What	Cost-Approved	Cost-Not App.
<b>Original Bid</b>	\$ 1,584,128.00	
VE#4 (app. Before contract)	\$ (12,200.00)	
VE#5 (app. Before contract)	\$ (5,600.00)	
VE#6 (app. Before contract)	\$ (4,800.00)	
VE#15 (app. Before contract)	\$ (25,000.00)	
<b>Contract Bid</b>	\$ 1,536,528.00	
RFP #1 (VE#7-bathrooms)	\$ (4,181.00)	
RFP #2 (VE#13-countertops)		\$ (4,100.00)
RFP#3A (VE#14-1" mini blinds)		\$ (1,862.00)
RFP#3B (VE#14-tink, no blinds)		\$ (7,585.00)
<b>RFP #4 (Plumbing Changes per Jeff)</b>	\$ 12,799.00	
RFP #5 (Basement HVAC Supply)	\$ -	
RFP #6 (Demo & Framing balancing)	\$ 6,623.00	
RFP #7 (New Entry Door)	\$ 6,983.00	
RFP #8 (Ceiling insulation-Fire Hall)	\$ 2,692.00	
RFP #9 (vault accent light)	\$ 504.00	
RFP #10 (install floor hatch)	\$ 4,371.00	
<b>RFP #11 (Exterior lighting)</b>	\$ (874.00)	
<b>RFP #12 (Delete 6 intereior blinds)</b>	\$ (2,228.00)	
<b>RFP #13 (Change light-Council Entry)</b>	\$ 1,522.00

#004

**SIDNEY CITY HALL REMODEL**  
Sidney, Montana

**1 - New Plumbing Plan - Main Floor**

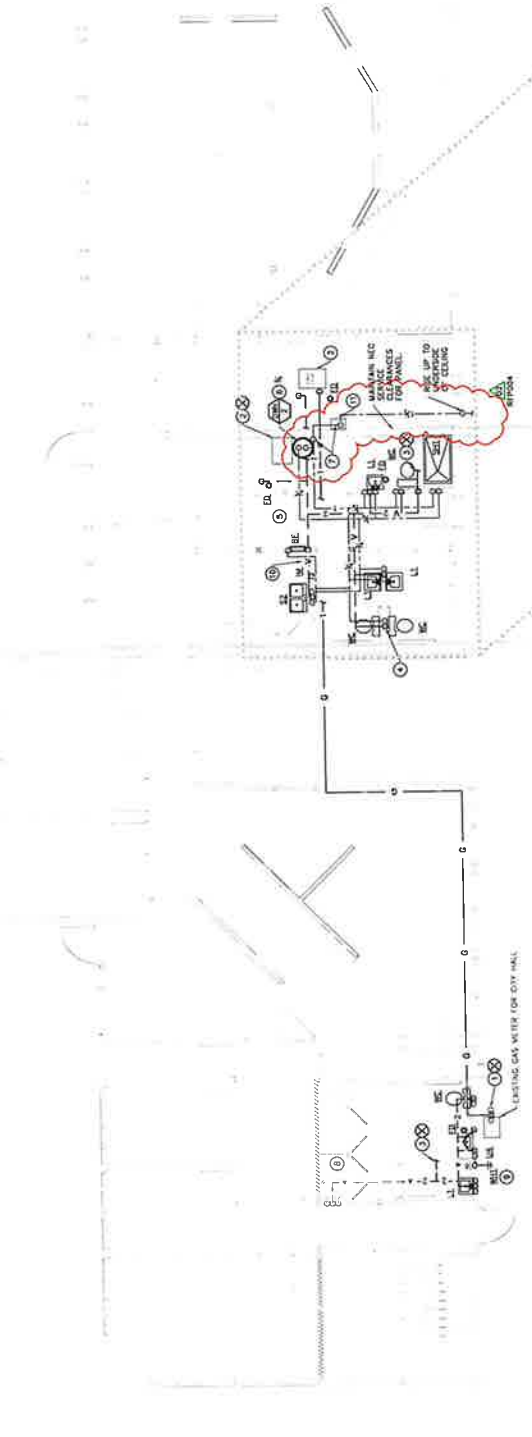
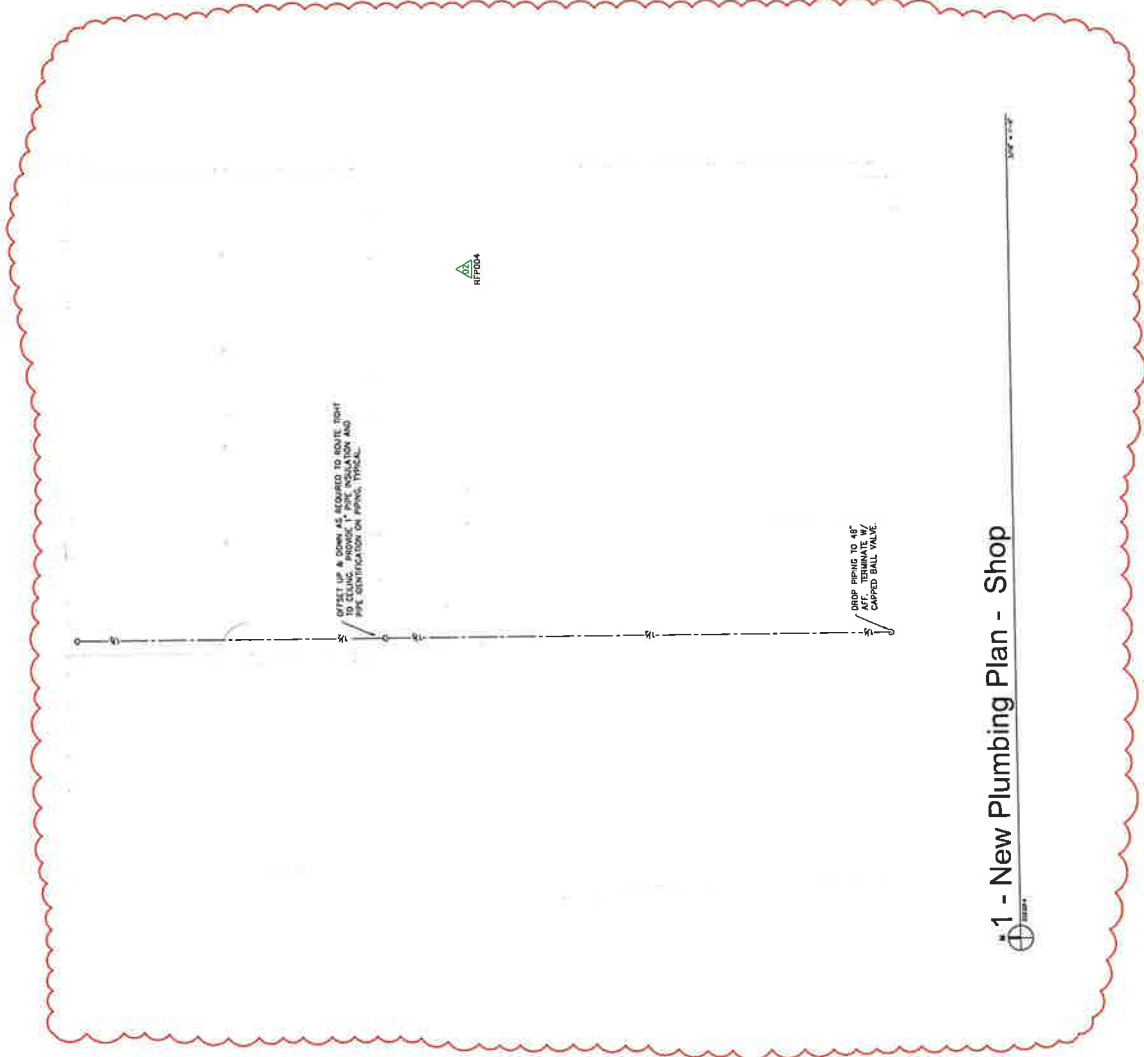
Provide cost to adjust the water entry and add an irrigation line per the attached revised drawings.

- 1. FIELD CAMERA WASTE PIPING TO BE REMOVED. REWORK/REWORKER TO REMOVE AND REWORK. SEE ARCHITECTURAL PLAN FOR LOCATION. REMOVE AND REWORK WASTE PIPING AND FITTINGS IN MECH ROOM TO BE IN LINE WITH EXISTING WASTE PIPING IN MECH ROOM. PATCH FLOOR TO MATCH EXISTING.

- 2. COORDINATE WASTE ROUTING AND FLOOR DEMOLITION REQUIREMENTS W/ GC.
- 3. EXISTING SERVICE SHAK TO REMAIN.
- 4. INSTALL NEW WALL HYDRANT IN THE LOCATION OF THE EXISTING HYDRANT. PROVIDE BALL VALVE FOR INSTALLATION. DESIGN SHOULD BE LOCATED IN FRONT OF BALL VALVE.

- 5. ROUTE WASTE FROM BE IN WALL TO SANITARY DROP FROM SINK.
- 6. SEE WATER SERVICE ENTRY DETAIL.
- 7. EXISTING 4" SAN DROP AND PINE CLEANOUT TO REMAIN.
- 8. FURNACE GAS SERVICE TO NEW FURNACE PER IGCC EQUIP CONNECTION DETAIL.

- 9. ROUTE GAS FROM FURNACE TO FURNACE ACCESS TO FURNACE.
- 10. ROUTE SANITARY WASTE CW AND HW IN COORDINATION WITH MECH ROOM CONTRACTOR. PROVIDE 1/2" ALLOW HANG DUCTWORK TO BE INSTALLED ABOVE FURNACE.

- 11. INSTALL NEW WATER HEATER. INSTALL PER TANK WATER HEATER DETAIL. UNIT CHANGE FROM GAS TO ELECTRIC TO COMPAT WITH FLOORING CONDITIONS.
- 12. RECONNECT SERVICES TO SERVICE SINK ABOVE.

DEBIT: **\$12,799.00**  
CALENDAR DAYS: **0 days**
